2nd Further Information

**Proposed Temporary Warehouse (excluding Dangerous Goods Godown) with Ancillary
Open Storage of Construction Materials and Facilities for a Period of 3 Years in
“Other Specified Use” annotated “Railway Reserve” Zone,
Lot 4115 (Part) in D.D. 104, Kam Tin, Yuen Long, New Territories**

Responses-to-Comments

(Application No. A/YL-KTN/1222)

Photographic Record showing the Existing Drainage Facilities on the Site

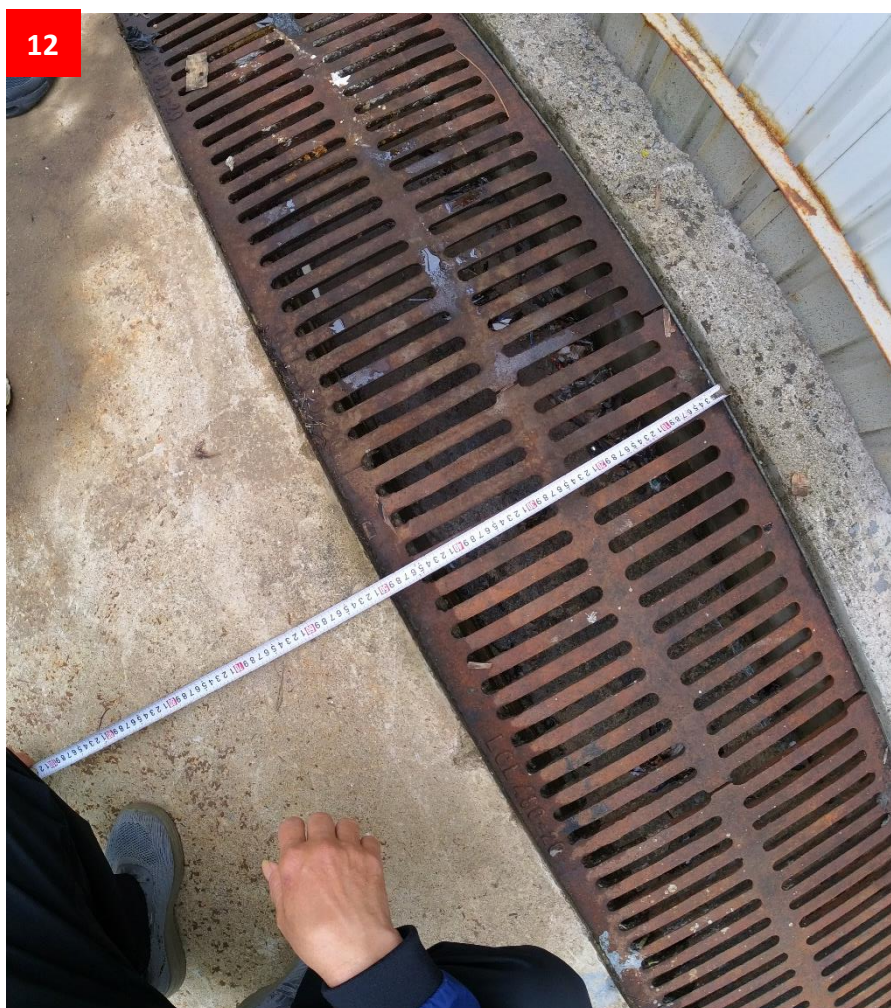
(a)	Leaves and debris were found in existing surface channels that water flow would be obstructed.	Leaves and debris have been cleaned by the applicant. Please refer to the updated photographic record for your consideration (Annex I)

(b)	Internal condition of some existing drainage facilities cannot be seen in the submitted photos.	
2. Comments of the Director of Fire Services (Contact Person: Mr. YUEN Tsz-fung; Tel: 2733 7737)

a) Accepted drainage proposal layout

b) Site photo taken on 3.3.2026 and 29.6.2026

Title:
Proposed Fire Service Installation
Layout Plan

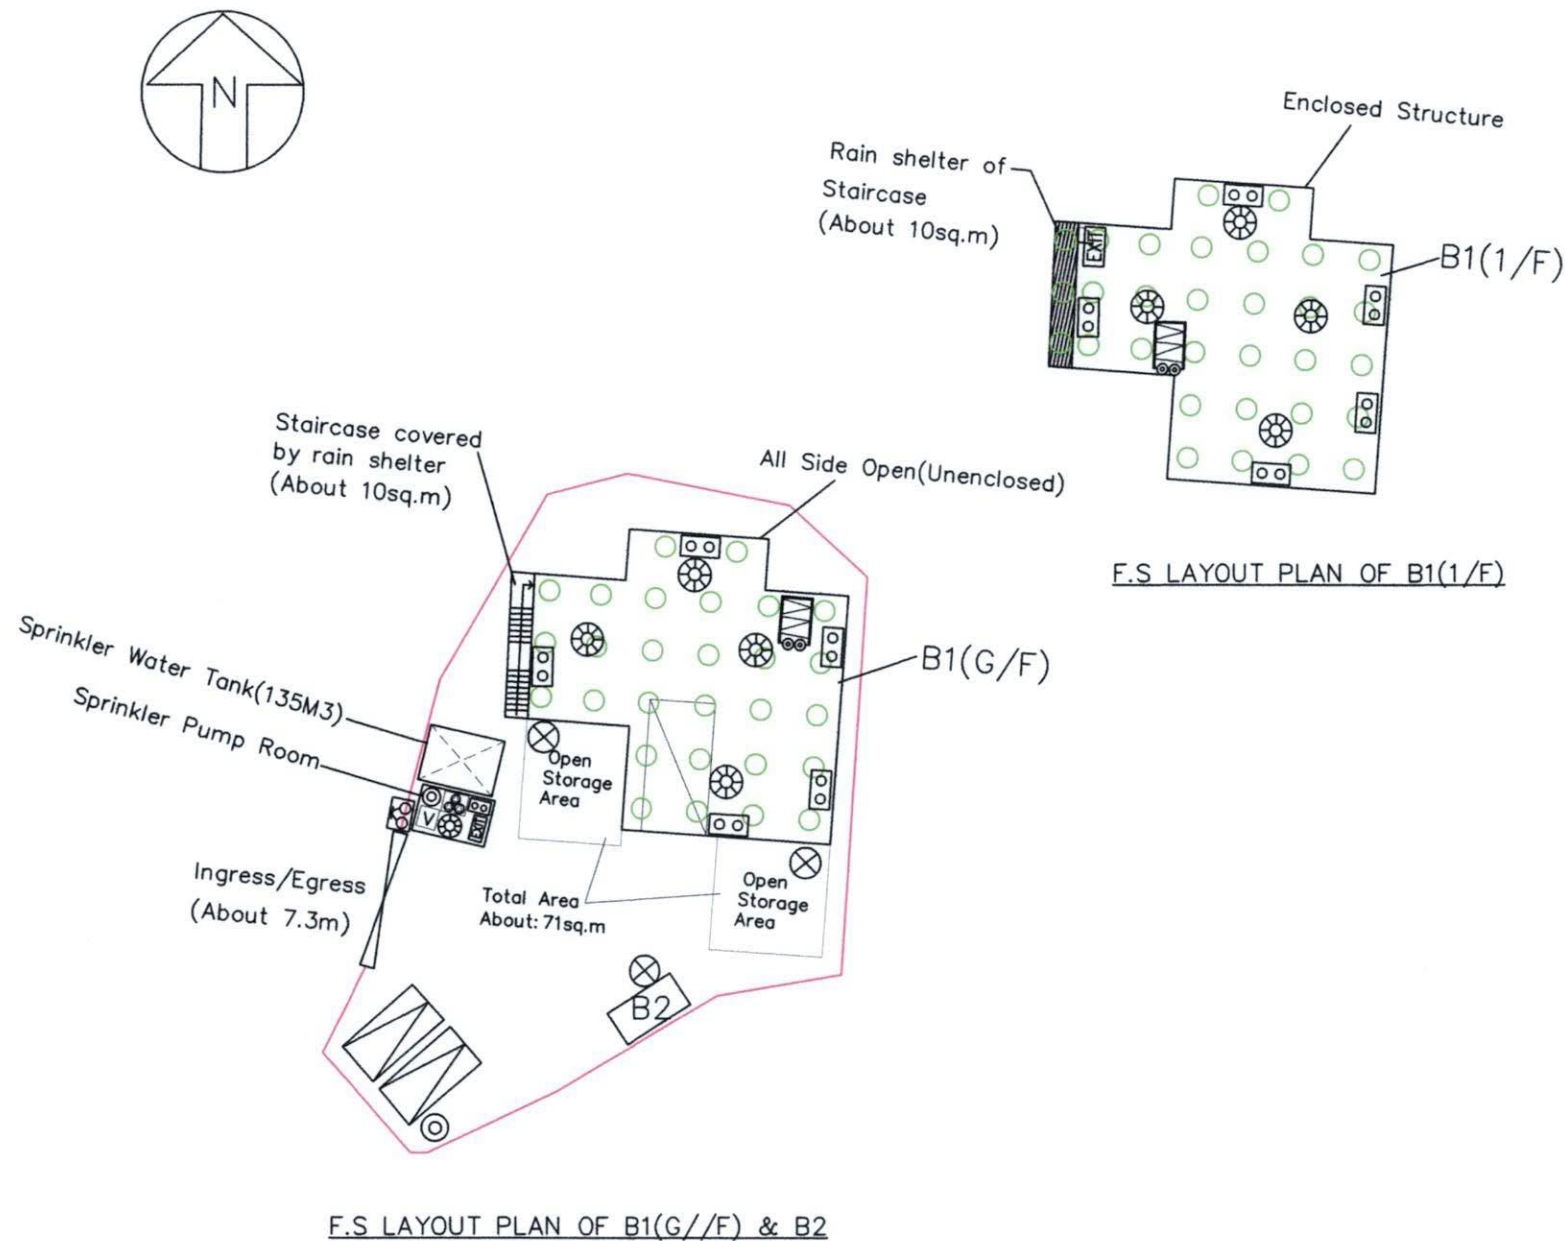
(a)	Stand-alone fire detectors and emergency lighting shall be provided on G/F of Structure B1;	A revised fire service installations proposal has been provided by the applicant (Annex II). Stand-alone fire detector, emergency lighting are provided on G/F of Structure B1.

(b)	The total floor area of open storage area shall be clearly stated on the plan; and	Noted and revised accordingly.
(c)	The numbering of structure as stated in item 6 of the FS Notes shall tally with the information on the plan.	Noted and revised accordingly.
